| 8802-3/802.3 REVISION REQUEST 1150 |

REQUESTED REVISION:
STANDARD: IEEE Std. 802.3-2002
CLAUSE NUMBER: 40C.2.1 and Figure 40C-2
CLAUSE TITLE: Auto-Negotiation Transmit state machine add-on
for 1000BASE-T

Figure 40C-2—Auto-Negotiation Transmit state diagram add-on for 1000BASE-T

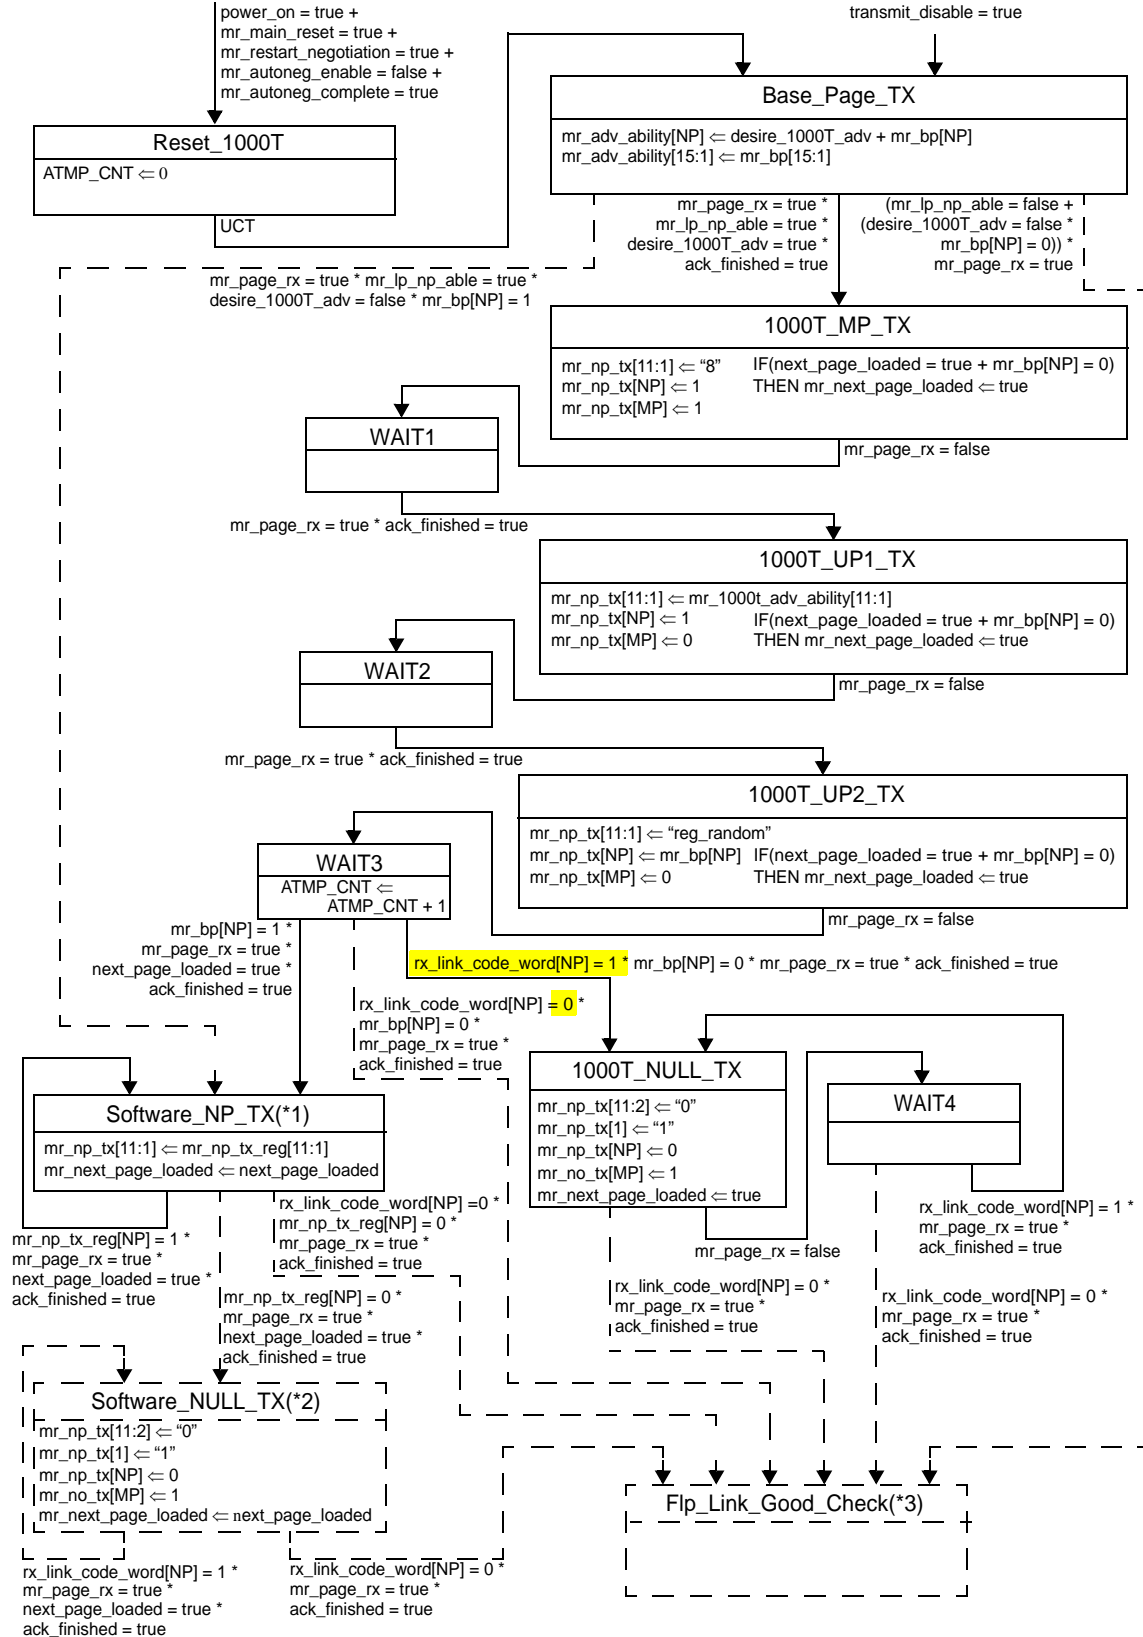
In Figure 40C-2, in the transition conditions between WAIT3 and
Flp_Link_Good_Check, change the transition condition from
rx_link_code_word[NP]=1 to rx_link_code_word[NP]=0.

Furthermore, rx_link_code_word[NP]=1 should be added to the transition
conditions between WAIT3 and 1000T_NULL_TX.

These additions were originally in request 1045 however the diagram
balloted did not implement these correctly.

Replace Figure 40C-2 with the following (Changed highlighted):
